WESTECH ENGINEERING, INC.
CONSULTING ENGINEERS & PLANNERS

December 10, 2018

RE: Stormwater for Kuebler Shopping Center

Figure 8 of May 31, 2018 TIA

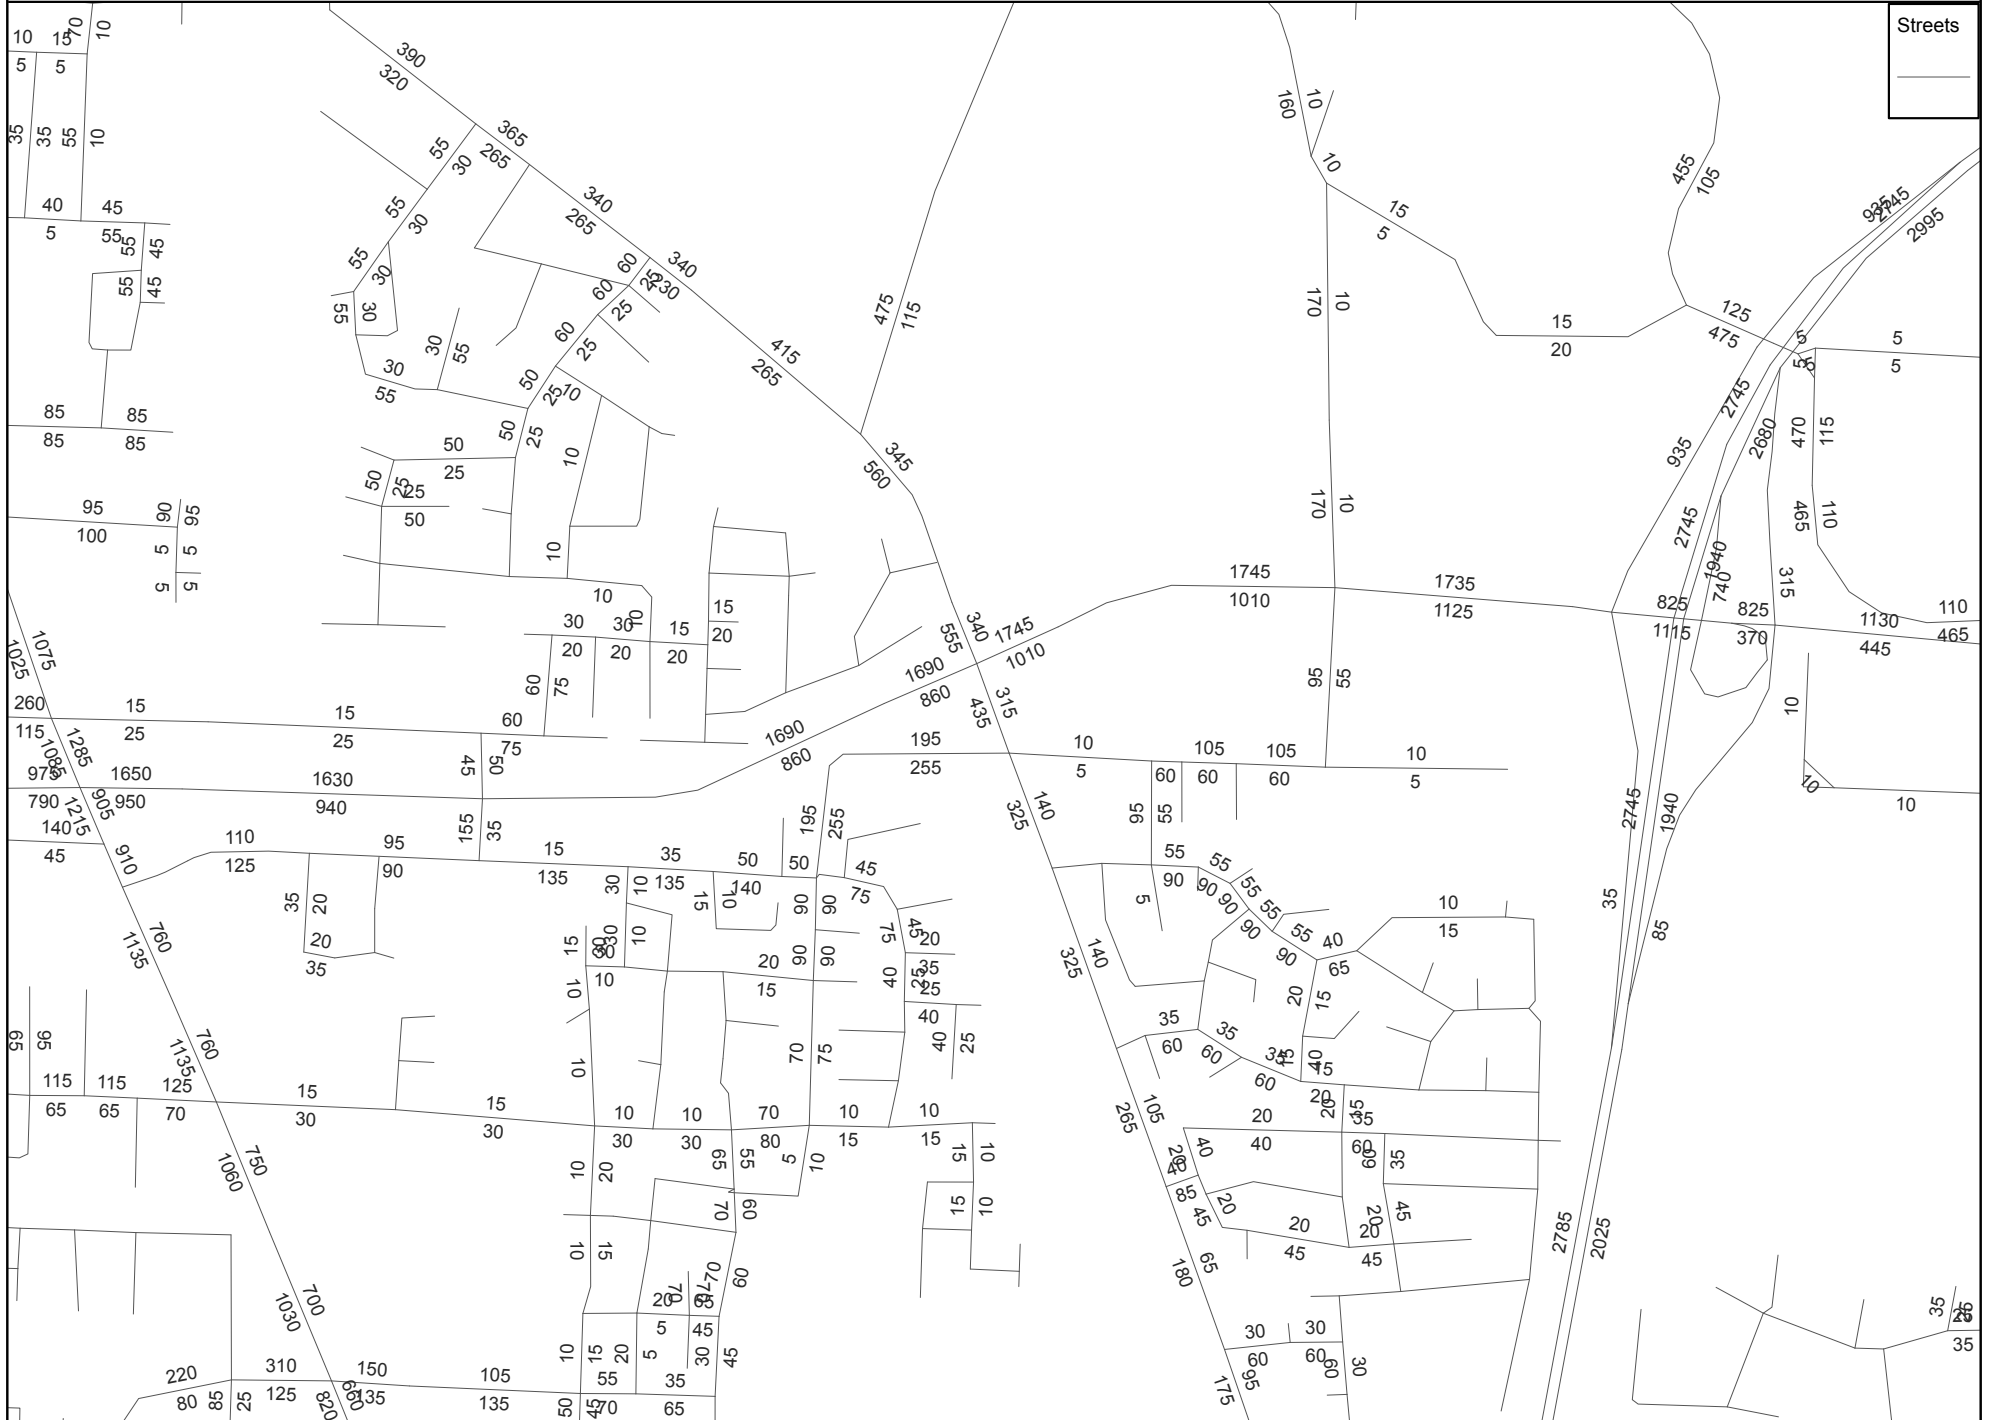
Additionally, Figure 8 of the May 31, 2018 TIA illustrates more than 50 weekday PM and Saturday peak hour trips distributed along Kuebler Boulevard east of I-5. At the very least, the city requires the Kuebler Boulevard/36th Avenue to be analyzed.

Figure 8 of the TIA appears to assume that not a single vehicle will arrive to the development via Cultus Avenue at Boone Road. For a good portion of the neighborhood to the south of Boone Road, it would be more expedient to arrive at the development via Cultus Avenue than another route. The TIA should address the impacts to this street and the other local streets in the area. Cultus Avenue should be evaluated for the provision described above. However, the TIA has not provided any traffic counts along this roadway nor does it evaluate this City Code provision in any way.
